194th session

Proposal for Supplement 1 to 04 Series of Amendments to UN Regulation No. 100 (Electric power trained vehicles)

Submitted by the Working Party on Passive Safety*

Figure 1
Schematic to Measure Wrap-Around Distance

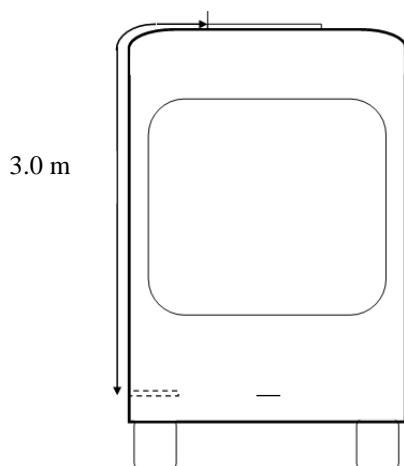
For vehicles of categories N₂, N₃, M₂, M₃, O₃ and O₄, conductive connection devices not energized except during charging of the REESS are exempted from this requirement if located on the roof of the vehicle out of reach for a person standing outside of the vehicle and, for vehicles of category M₂ and M₃, the minimum wrap around distance from the instep of the vehicle to the roof mounted charging devices is 3 m. In case of multiple steps due to an elevated floor inside the vehicle, the wrap around distance is measured from the bottom most step at entry, as illustrated in Figure 1."

Figure 1
Generic description of test pulses

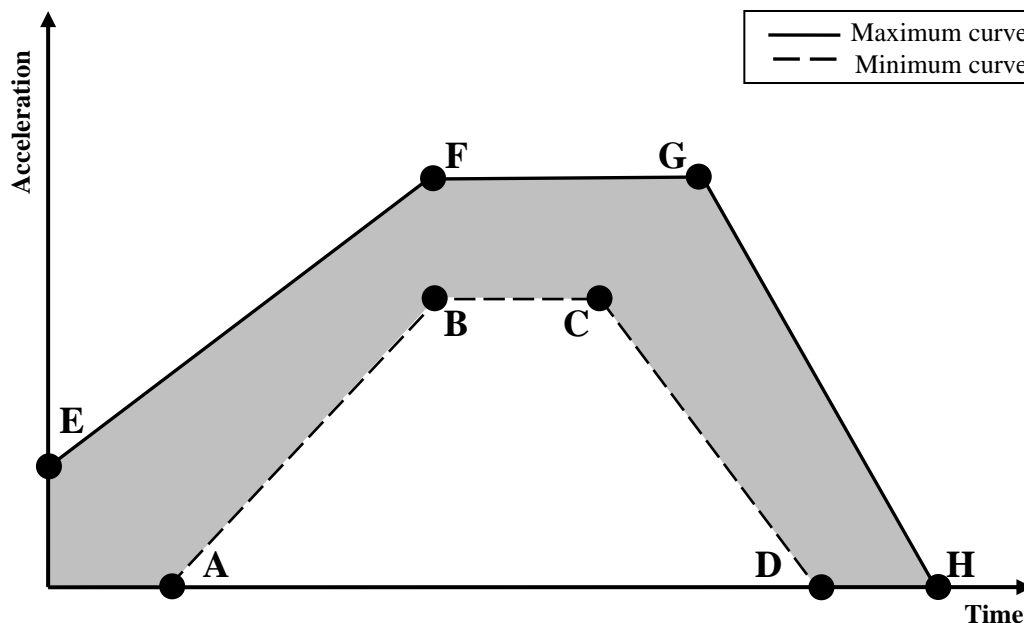
Annex 9C, paragraphs 3.2., amend to read:

The Tested-Device shall be decelerated or accelerated in compliance with the acceleration corridors which are specified in Tables 1 to 3. The manufacturer shall decide whether the tests shall be conducted in either the positive or negative direction or both.

The test pulse shall be within the minimum and maximum value as specified in Tables 1 to 3. A higher shock level and /or longer duration as described in the maximum value in Tables 1 to 3 can be applied to the Tested-Device if recommended by the manufacturer.

Table 1 for M₁, N₁, O₁ and O₂ vehicles¹:

Point	Time (ms)	Acceleration (g)	
		Longitudinal	Transverse
A	20	0	0
B	50	20	8
C	65	20	8
D	100	0	0

E	0	10	4.5
F	50	28	15
G	80	28	15
H	120	0	0

Table 2 for M₂ and N₂ vehicles:

Point	Time (ms)	Acceleration (g)	
		Longitudinal	Transverse
A	20	0	0
B	50	10	5
C	65	10	5
D	100	0	0
E	0	5	2.5
F	50	17	10
G	80	17	10
H	120	0	0

Table 3 for M₃, N₃, O₃, O₄ vehicles:

Point	Time (ms)	Acceleration (g)	
		Longitudinal	Transverse
A	20	0	0
B	50	6,6	5
C	65	6,6	5
D	100	0	0
E	0	4	2.5
F	50	12	10
G	80	12	10
H	120	0	0

- "1. For vehicles of category O₁ and O₂ at the request of the manufacturer the pulses defined in table 2 of Annex 9C paragraph 3.2 may be used if the maximum design speed of these vehicles of category O₁ and O₂ is limited to 100 km/h."
